ENVIRONMENTAL REVIEW COMMITTEE REPORT

ERC MEETING DATE:	February 27, 2012		
Project Name:	Heritage Hills Apartments PUD		
Owner:	Weidner Property Management, 9757 Juanita Drive NE suite 300, Kirkland, WA 98034		
Applicant/Contact:	Greg Sparhawk, Complete Construction, 9757 Juanita Drive NE Suite 300, Kirkland, WA 98034		
File Number:	LUA11-091, ECF, PPUD, FPUD		
Project Manager:	Vanessa Dolbee, Senior Planner		
Project Summary:	<p>The applicant is requesting Environmental Review (SEPA), Preliminary and Final Planned Urban Development (PUD) for the construction of a 125,539 square foot, 75-unit apartment building. The subject site is located at 1250 South Puget Drive and is zoned Commercial Arterial (CA). The site is 1.56 acres in size and contains 9,921 square feet of protected slopes. The proposed development would result in a density of 59.5 dwelling units per acre and no commercial component is proposed. Access to the site is proposed via the internal street system on the property to the north and all parking is proposed within an underground parking garage. A secondary gated emergency access point would be provided directly off of Puget Drive. The development would result in a

EXHIBIT 3

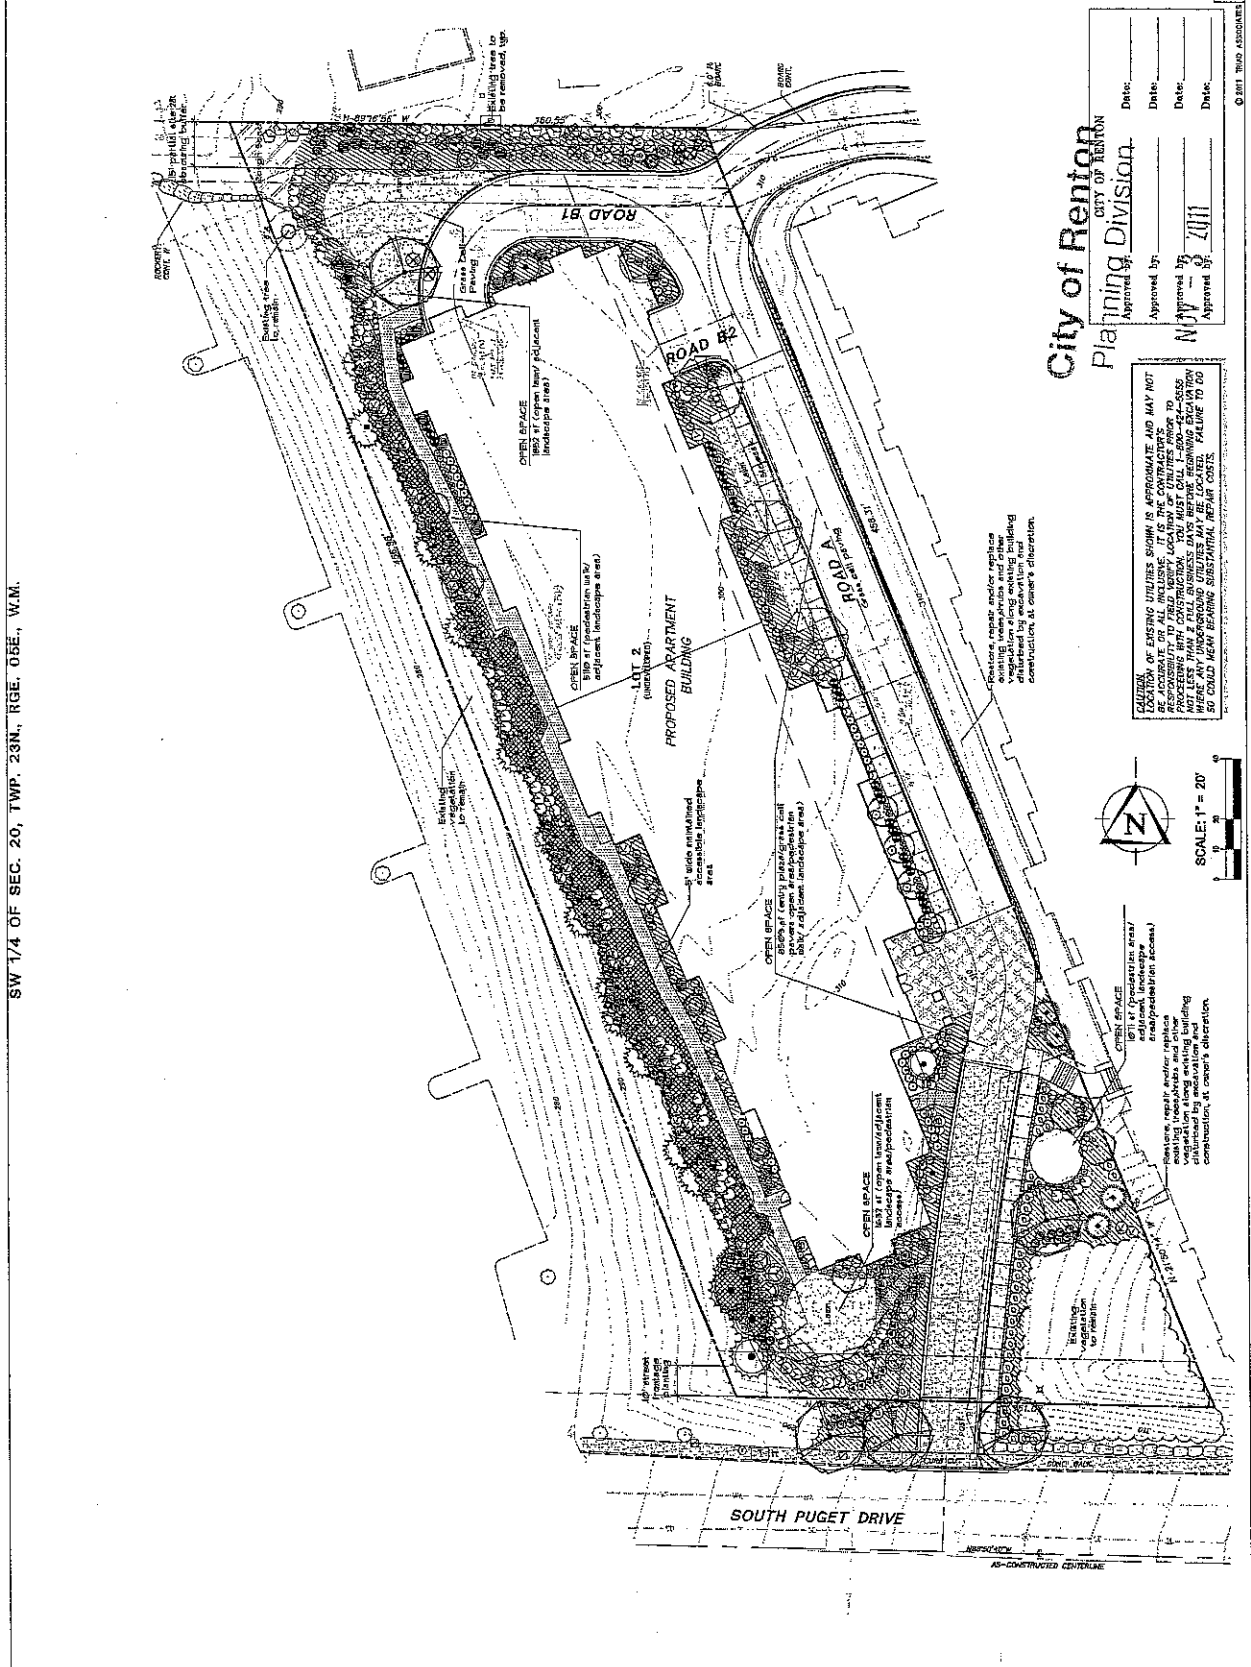
Exhibit 3, slope analysis, identifies the areas of protected slopes located on the subject site. Moreover, the steepest portion of the west slope and portions of the south slope are protected slopes while all other portions are either sensitive slopes or do not qualify. As discussed above, the native glacial till soils are highly consolidated and are inherently stable. The Geotechnical Report concludes that the proposed development would not adversely affect the stability of the site slopes nor adjacent properties and the risk and hazards associated with instability would be minimal, provided adequate measures for controlling site drainage and erosion are included in the design.

- a. The building foundations that parallel the slope crest shall be set back a minimum distance of ten feet from the face of the slope as measured from the edge of the footing at the bottom of footing elevation. This setback shall be shown on the site plan submitted with the building permit application. Compliance with this requirement would be reviewed and approved by the Building Plans Reviewer.
- b. A monitoring program should be implemented to verify the performance of the shoring system and possible excavation effects on adjacent properties.
- c. Excavating and grading should be completed between the end of April through the end of October or as approved by a Geotechnical Engineer or the Development Services Division, to reduce slope erosion.
